Re: Drop Size Distribution Retrieval Using Dual Frequency Polarimetric Weather Radars

Dear Editorial Team of AMT,

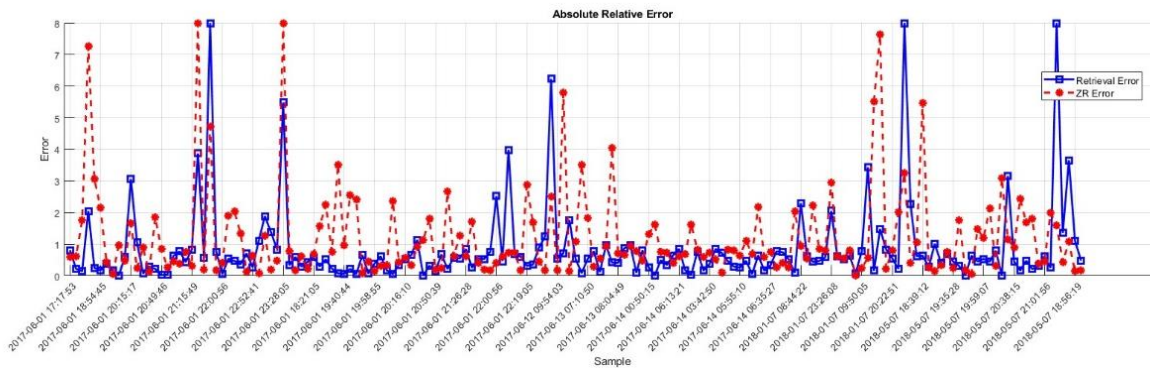
While the abstract states that the retrieval method “is able to accurately retrieve the gamma distribution parameters without the constraints required in previous methods” (line 9), the manuscript does not present any retrieved parameters, nor does it estimate the accuracy of any retrieved parameters. Thus, it is not possible to evaluate the accuracy of the proposed method because the necessary results are not presented in this manuscript.

The time series plot presented below illustrates the RAE results for two different approaches. Approach i, our proposed method, is represented by the blue line, while Approach ii, which employs the conventional $R(Z)$ method, is indicated by the red line. The plot demonstrates that estimating rainfall rates using retrieved DSD parameters, as in our proposed approach, yields higher accuracy compared to the traditional Z - R relationship. Specifically, the median RAE for the Z - R approach stands at 0.72, which is notably reduced to 0.53 with our proposed method. This represents a significant improvement of 26.4% as observed in this study.

In the revision, the quantitative evaluation results and discussions will be added.

The Performance Evaluation section has undergone major revision in order to address this. Updates were made exactly as were outlined in the interactive discussion response.

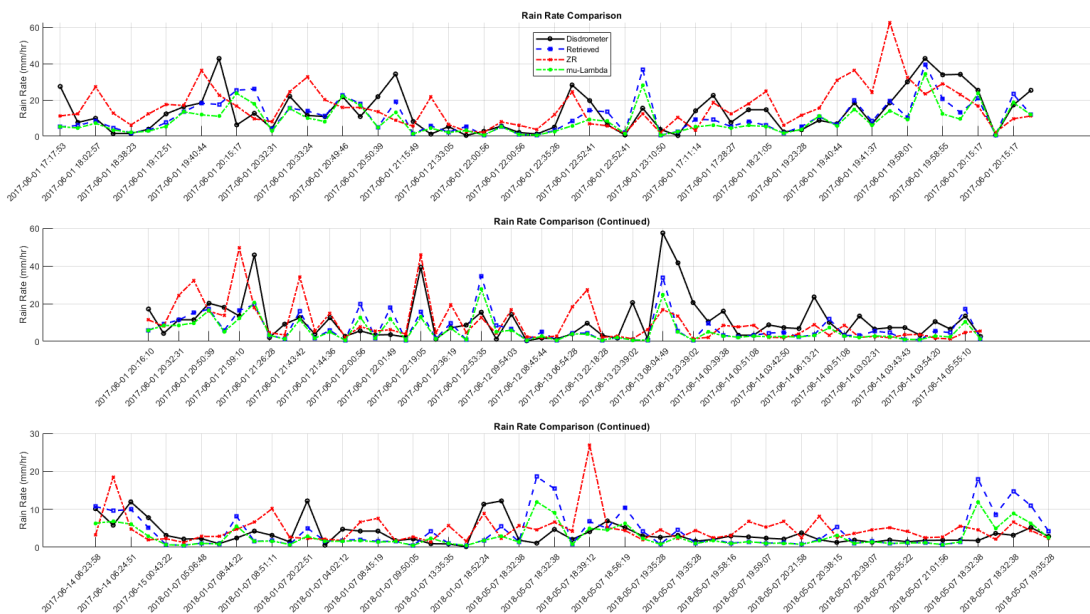
5. How much improvement in rainfall estimation does the proposed method provide compared to using one of the mu-lambda relationships proposed by Zhang et al. (2001), Brandes et al. (2002), or Cao et al. (2010)? If the new method does not produce comparable or better rainfall estimates than the mu-lambda constraints, then will this proposed method be an improvement to QPE? The mu-lambda constraints should be the baseline that the new method should aim to beat. In summary, without the manuscript showing results of the retrieved DSD parameters, it is not possible to evaluate the proposed retrieval method. The proposed method may produce results that are superior to results from imposing a mu-lambda constraint. But, as written, the manuscript does not show the evidence needed to verify the statements made in the manuscript.

The following figure shows the rain rate derived from the proposed method's retrieval (blue), the disdrometer truth (black), Z-R relation (red), and the PSO retrieval with a μ - Λ constraint (green).

The accuracy of the μ - Λ constrained retrieval method is found to be comparable to that of our unconstrained retrieval technique. Evaluating performance with the RAE metric reveals that the constrained approach has a median error of 0.55, closely aligning with the unconstrained method's median error of 0.53. While a mean RAE evaluation might suggest enhanced performance with the μ - Λ relationship, we believe using median values for assessment provides a truer reflection of performance, particularly due to the influence of outliers. To illustrate this, the attached figure displays error plots for all methods, with outliers truncated at a value of 8.

The Performance Evaluation section has undergone major revision in order to address this. Updates were made exactly as were outlined in the interactive discussion response.

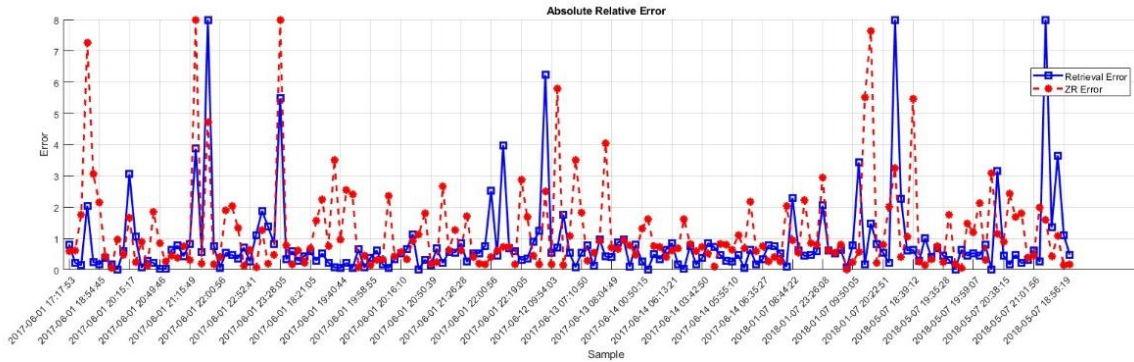
3) I suggest performing the DSD retrieval at the terminal gate continuously for at least several radar scan to check robustness of the proposed method.

The time series plot presented below illustrates the RAE results for two different approaches. Approach i, our proposed method, is represented by the blue line, while Approach ii, which employs the conventional R(Z) method, is indicated by the red line. The plot demonstrates that

estimating rainfall rates using retrieved DSD parameters, as in our proposed approach, yields higher accuracy compared to the traditional Z-R relationship. Specifically, the median RAE for the Z-R approach stands at 0.72, which is notably reduced to 0.53 with our proposed method. This represents a significant improvement of 26.4% as observed in this study.

Multiple back-to-back scans at the terminal gate are not present in our dataset due to the tight time synchronization requirements and data quality standards, however robustness has been included in the re-evaluation of the dataset. Please see updated manuscript Section 3.2 beginning line 320 or redline version line 366.

Figure 1

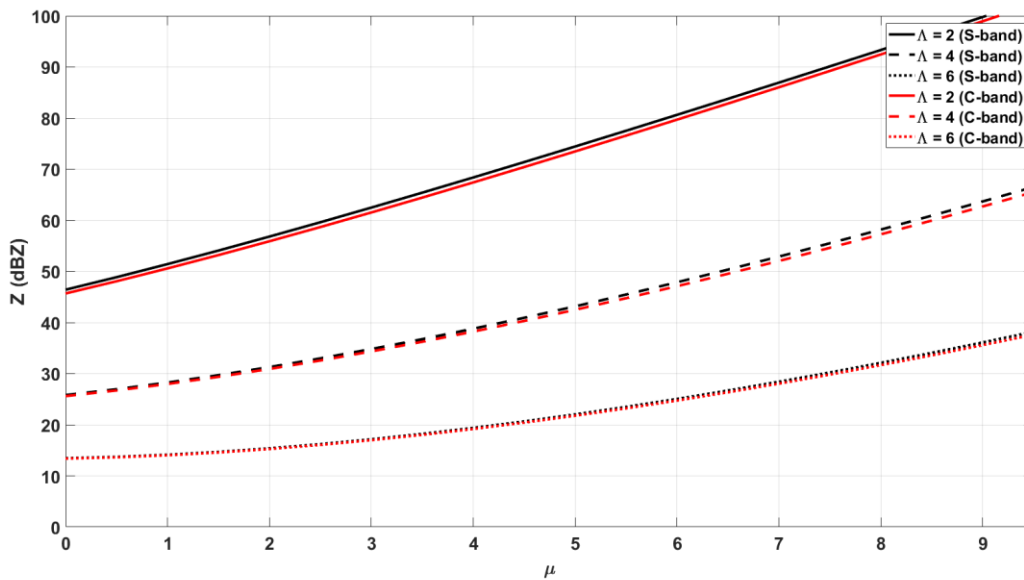
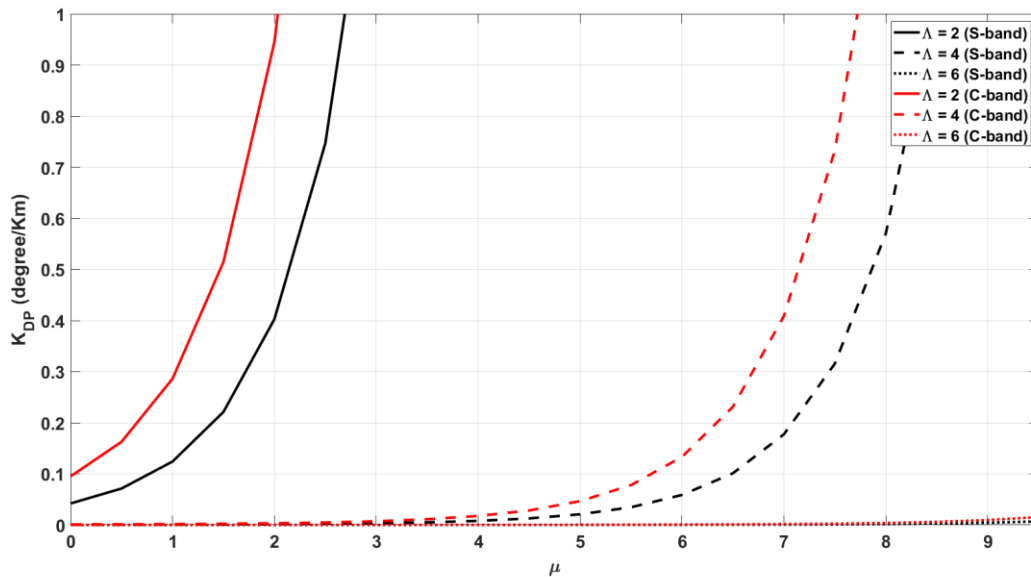
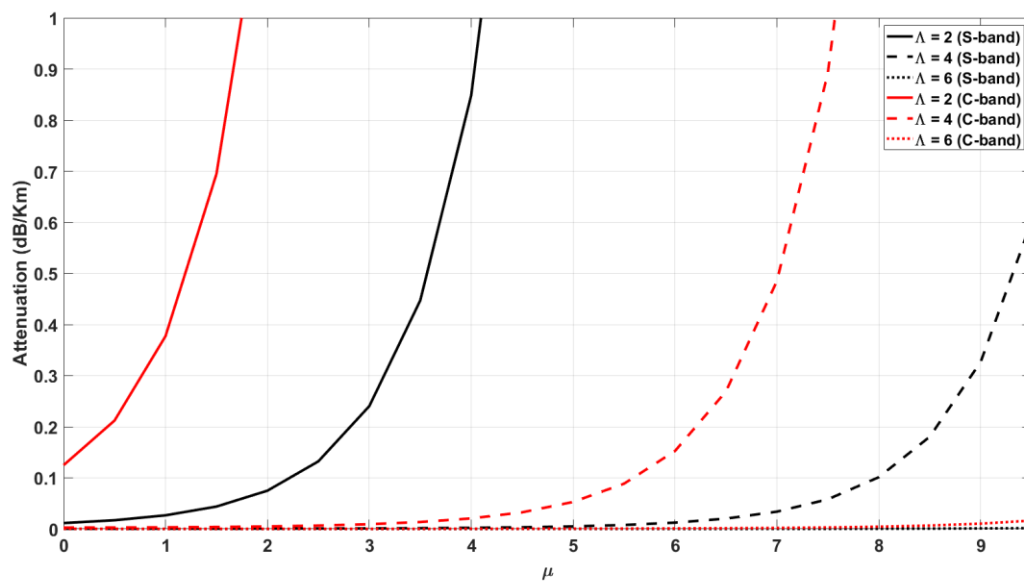
Usually, algorithms are first investigated in ideal conditions (i.e. through T-matrix simulated measurements) and then the performance is investigated in the presence of different error sources (i.e. calibration, attenuation, spatial gradient, difference in volume sampling, etc.) and finally validated with real measurement and comparison with real data

Figure 1 – Simulated Reflectivity For Various Parameters – The S and C-band returns are too similar to provide independent information for retrieval purposes.

Figure 2 – KDP Variation For Various Parameters – The S and C-band returns very in KDP values which is a key premise of the algorithm. KDP values separate at the two frequencies at low and moderate values of Λ . The high values of Λ do not provide useful separation as can be inferred by such a quickly collapsing distribution.

Figure 3 – Attenuation Variation For Various Parameters – As expected, the attenuation is much greater at C-band relative to S-band. Large separation in attenuation values are present for identical gamma parameters.

The simulations reveal a pronounced attenuation in the C-band reflectivity field, whereas the attenuation observed in the S-band reflectivity is significantly less pronounced. Furthermore, a clear separation of KDP values is present at each band. These findings underpin our selection of these specific variables and illustrate the methods through which they can be leveraged for retrieval processes.

A simulation and resulting discussion have been added to the manuscript per the reviewer's suggestion. Figure 9, Line 290-299, relines 333-342.

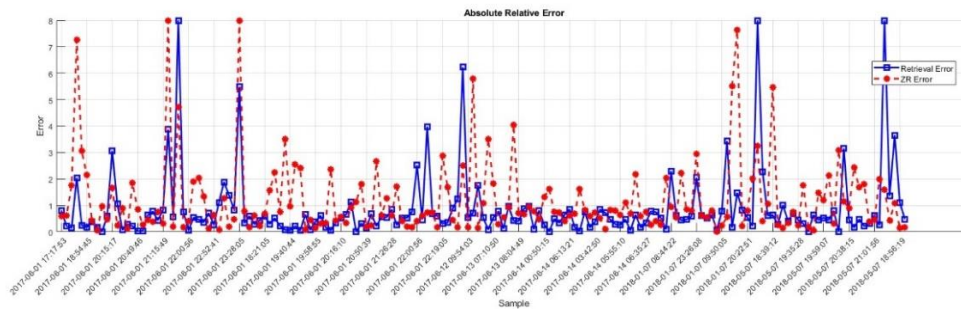
Only a very limited comparison with a Parsivel is shown that could be influenced by many sources of errors, including the limitation of the Parsivel itself (authors honestly use “qualitatively” word). However, even for this case, the error associated with the retrieval is not provided, and the range of variability of retrieved data is not provided as well.

Moreover, the technique is not checked against techniques based on single frequency dual-polarization radar that can be found in the literature so that a reader can understand the advantage of having two radars instead of a cheaper single radar.

for the Z-R approach stands at 0.72, which is notably reduced to 0.53 with our proposed method. This represents a significant improvement of 26.4% as observed in this study.

The Performance Evaluation section has undergone major revision in order to address this. Updates were made exactly as were outlined in the interactive discussion response.

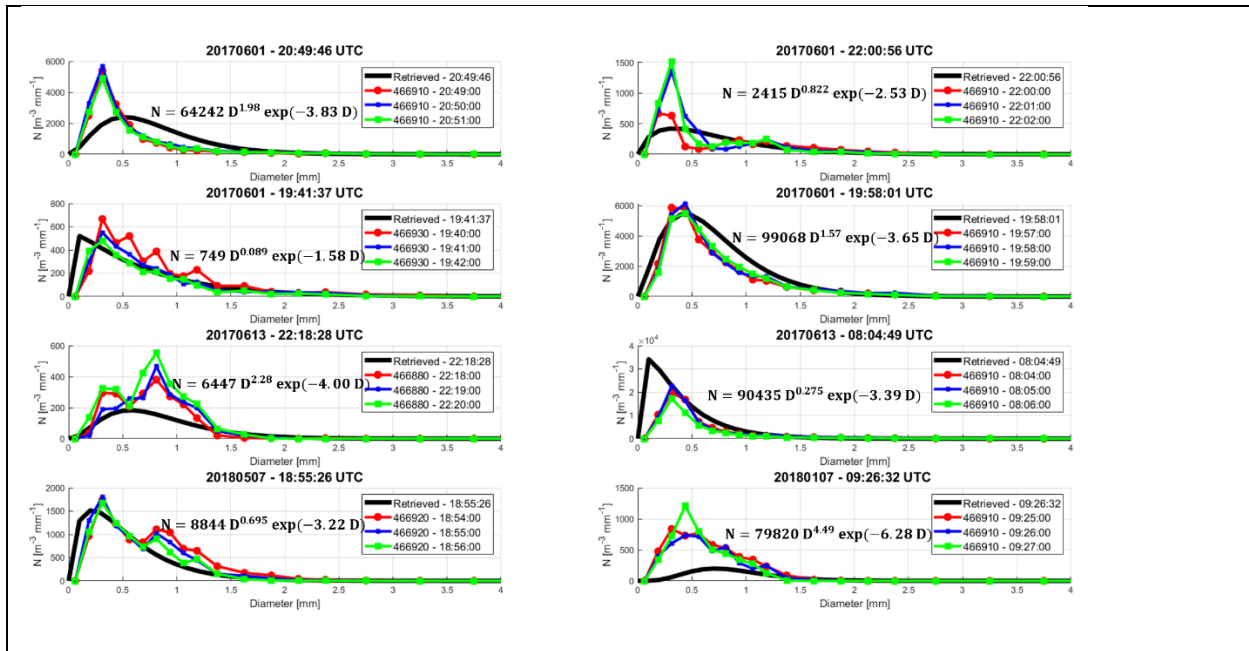
Reviewer: RC3	Comment Number: 45
Comment: g) Fig 8. This is just visual inspection hampered by the linear scale for N. A meaningful comparison should be done in terms of DSD parameters for a meaningful dataset.	
Interactive Discussion Response Provided: We acknowledge that visual inspection alone is insufficient to validate our methodology. To address this, we have compared the improvements in quantitative precipitation estimation (QPE) accuracy, using our method against Z-R derived rain rates, to fulfill the requirement for a statistical evaluation against recognized benchmarks. Nonetheless, we maintain that the subjective comparison of the retrieved DSDs with disdrometer data contributes valuable insights to our study. Due to modifications in our methodology, which now restricts the solution space to only allow positive values of μ (previously within the range of $-2 < \mu < 12$), our earlier qualitative plots have become obsolete. The revised example plots, demonstrating gamma distribution parameters for each retrieval, are presented in the subsequent figure. For most cases, employing a linear y-scale has proven to offer a better dynamic range. Therefore, we prefer to maintain consistent scaling across different cases for clarity and comparability.

We have revised the example plots. Please see Figure 8.

Figure 4

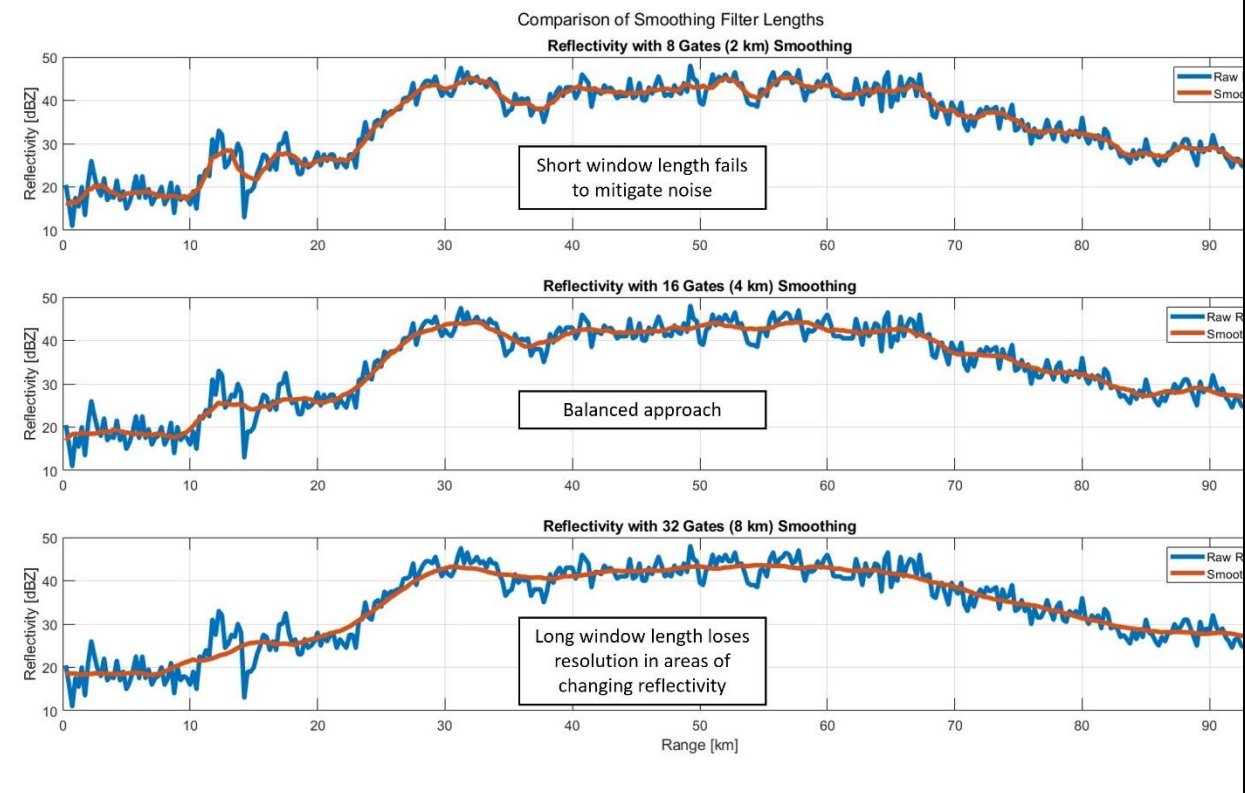
3.) What is the effect of the 4km averaging window, isn't this causing the radar quantities to be affected by returns that are up to 4 km away? By judging from figure 4 it seems that the averaging window is not applied as a moving average but rather at discrete points every 4km, does this mean that the bin center of the radar range can be up to 2 km away from the disdrometer position?

Figure 4 – Parameter Smoothing Example – An approach that balances smoothing and information preservation is clear.

Figure 4 (of the manuscript) may have led the reader to believe filtering was applied only at 4 km points. The filtering was applied as a moving average, however for the along-beam retrieval, discrete points are chosen to operate on. We will add a brief note to the revised manuscript to avoid any confusion.
